Docket Nos. 50-413  
and 50-414

Subject: Transmittal of Preliminary Draft SERs -  
Catawba Nuclear Station

HYDROLOGIC ENGINEERING SUMMARY  
CATAWBA NUCLEAR STATION

Figure 2.5-1. Typical Section of SNSWP Dam at Catawba Nuclear Station  
(Ref. FSAR Vol. 2)

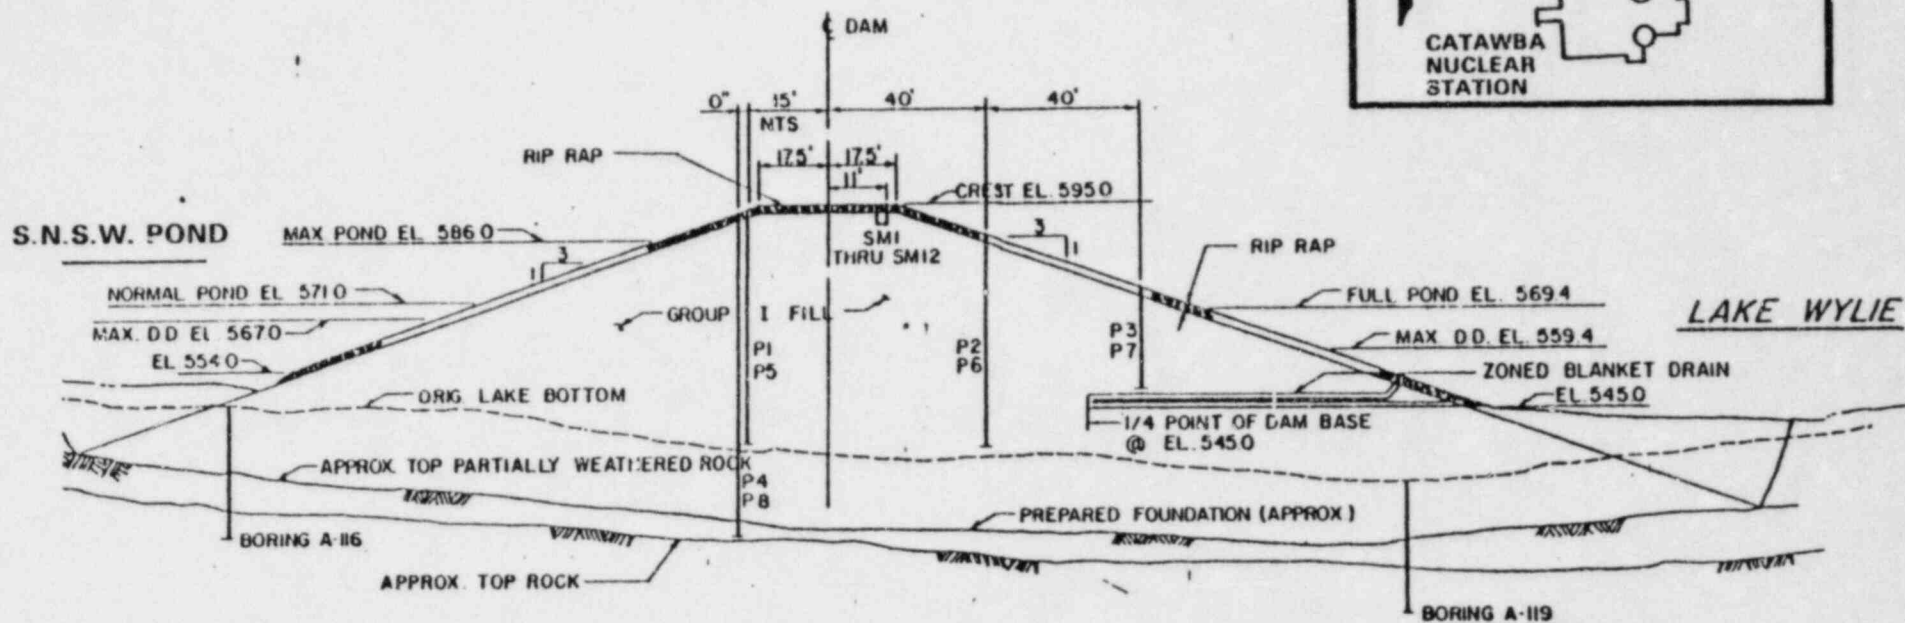
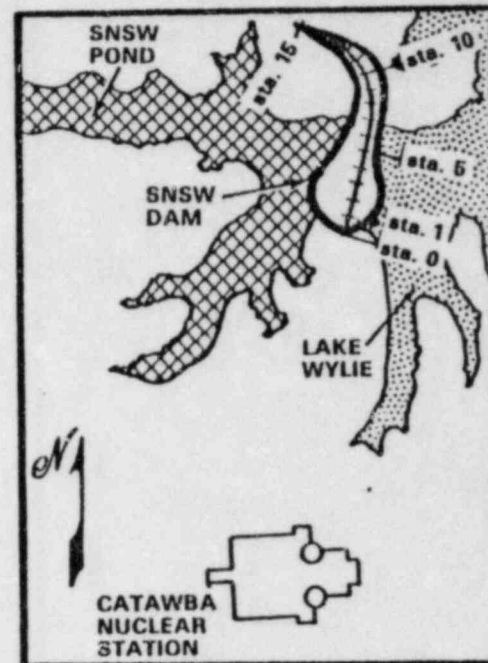
homogeneous, rolled, earthfill structure. The dam has a crest width of 35 ft and extends 1710 ft between abutments at crest elevation 595. The maximum height of the dam is 75 ft with upstream and downstream faces sloped at 3 to 1 (horizontal to vertical). All surfaces including the crest are protected against wave action with stone riprap. A typical cross section of the SNSWP Dam is provided in FSAR Figure 2.5.6-1 and is included herein (SER Figure 2.5.1). The centerline of the dam is oriented North 22° East from the south abutment for about 656 ft, then follows a circular curve for approximately 272 ft, and then runs North 39° West approximately 782 feet to the north abutment. The SNSW Pond is operated between full pond elevation ~~EL. 571~~ and maximum drawdown elevation ~~EL. 567~~ while the full pond elevation and maximum drawdown elevation of Lake Wylie are <sup>EL.</sup> 569.4 and ~~EL.~~ 550 respectively. (The applicant has stated in FSAR Section 2.5.6.6.2 that the Lake Wylie pool level may drop to ~~EL.~~ 550 while the maximum drawdown elevation is shown as <sup>EL.</sup> 559.4 in FSAR Figure 2.5.6-1. The applicant may clarify this discrepancy).
